100 MOhm-MOX-400_23 (all)

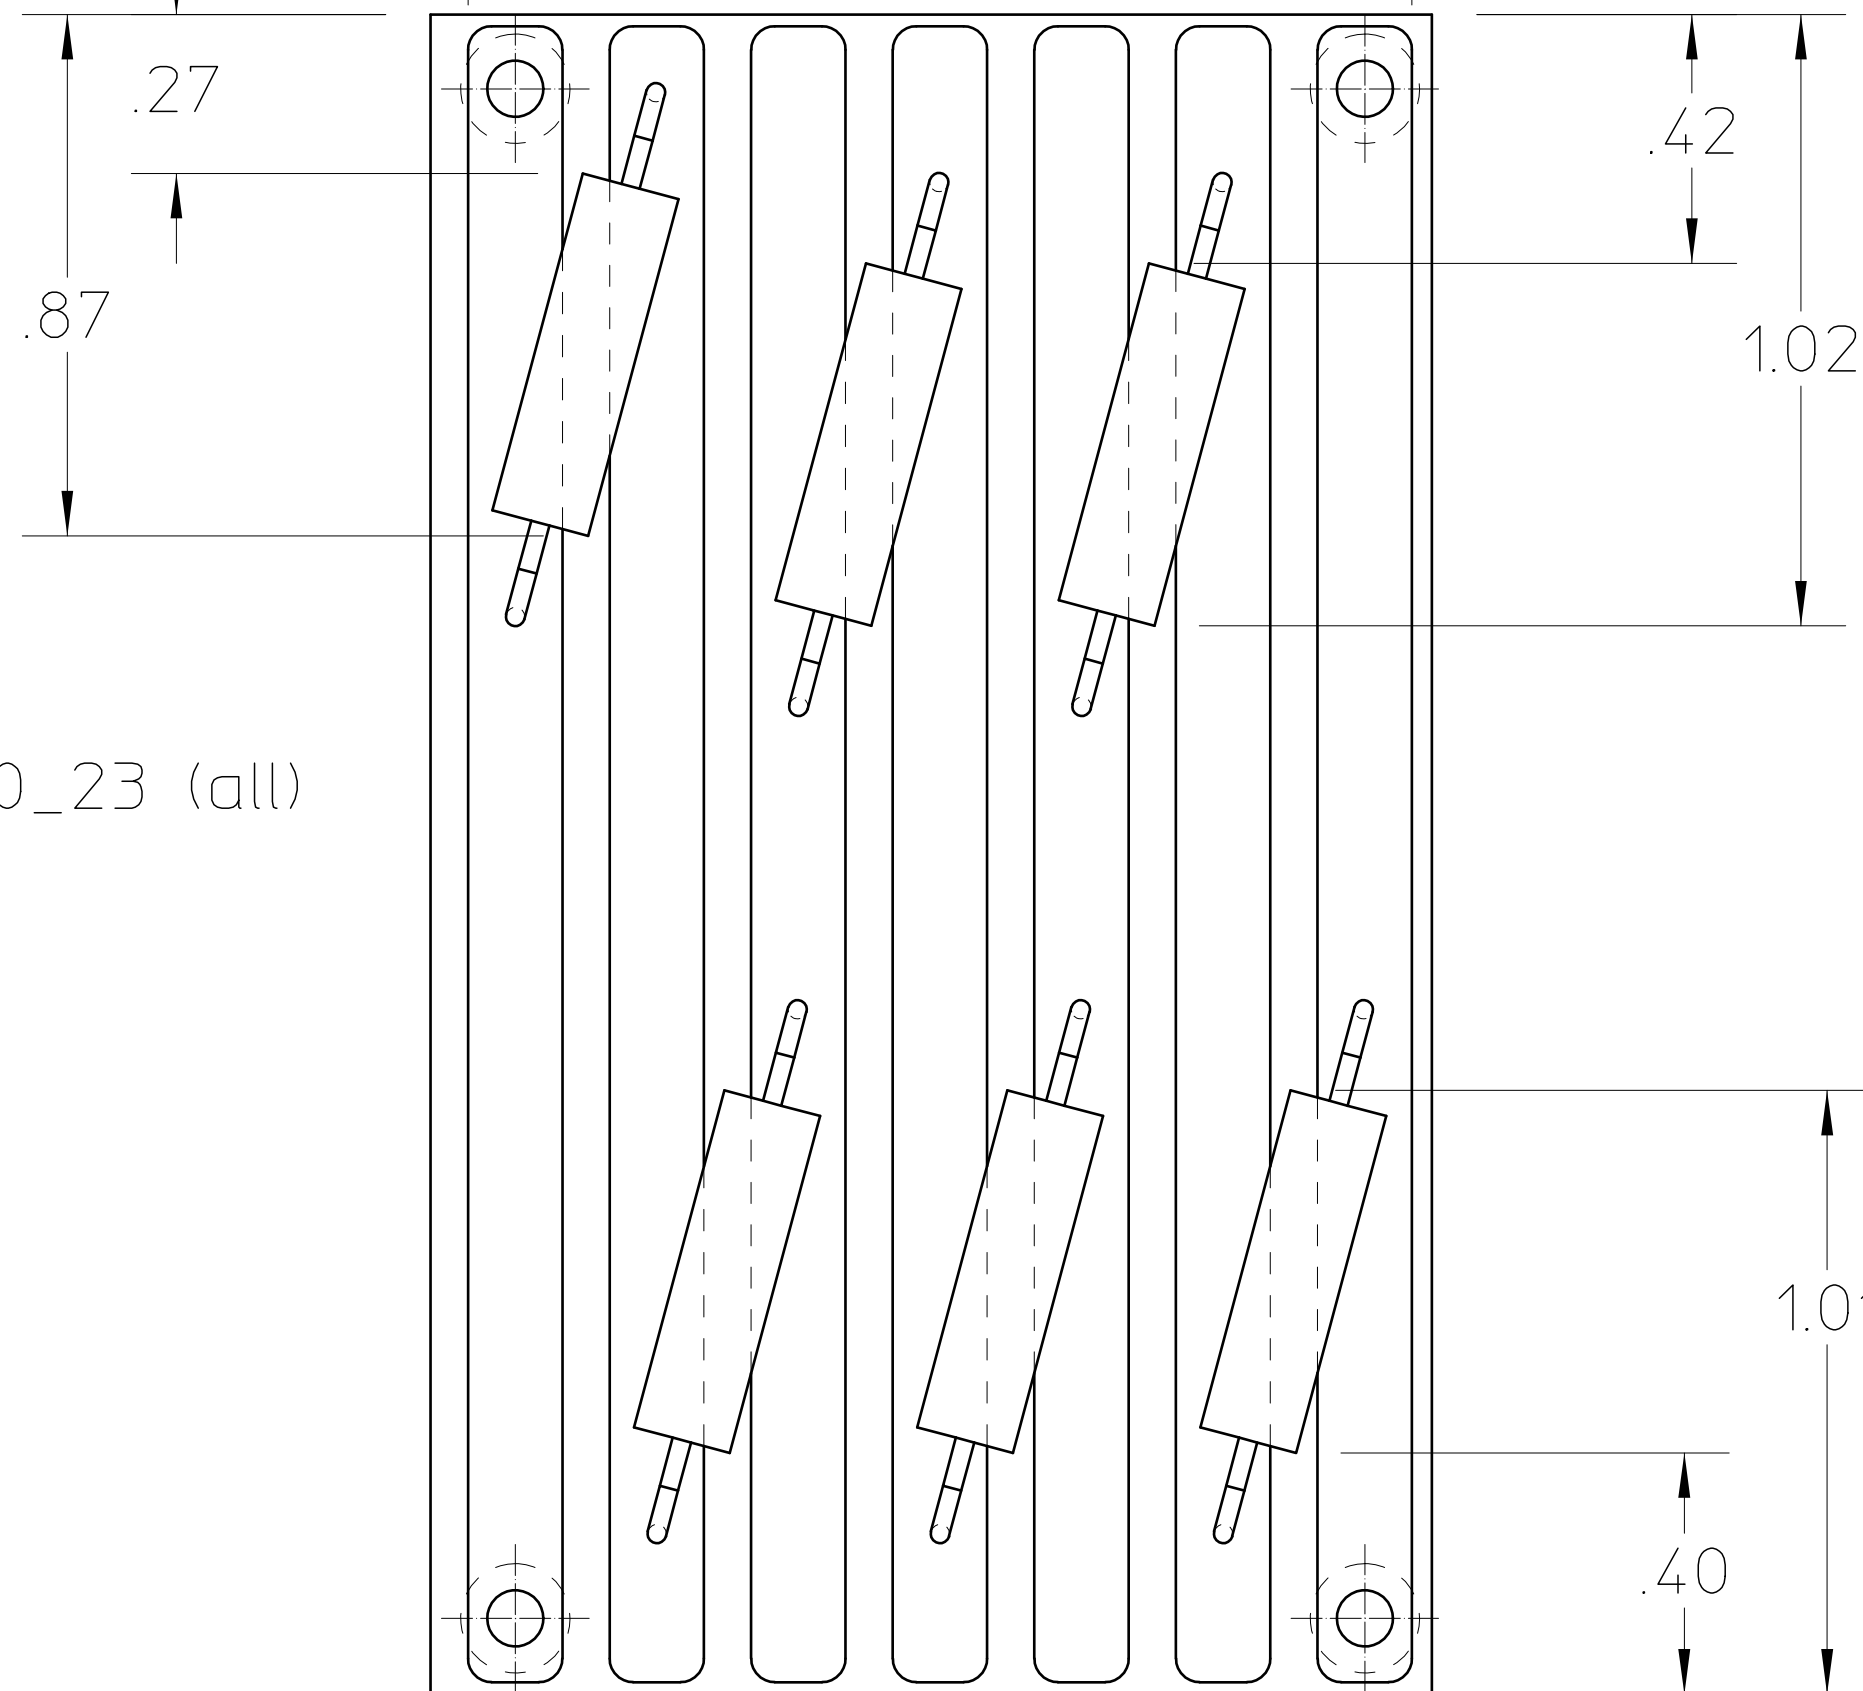
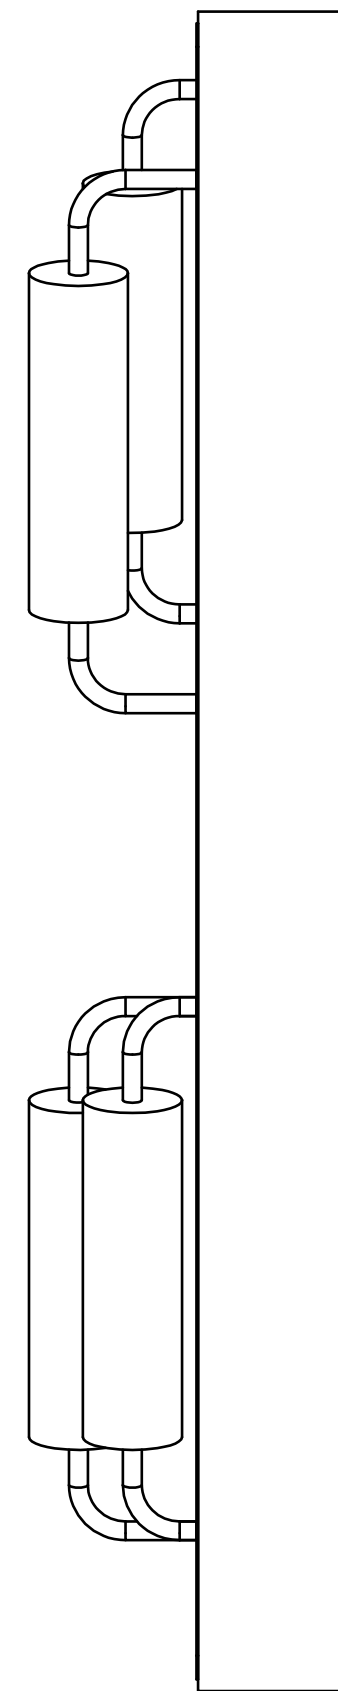
LEADS TO HAVE FLAT SECTION ADDED (.1"/.2" LG.) FOR PAD CONTACT
BEND LEADS CLOSER TO RESISTOR BODY TO PROVIDE FLAT SECTION

note wide margin .06

.03 note narrow margin
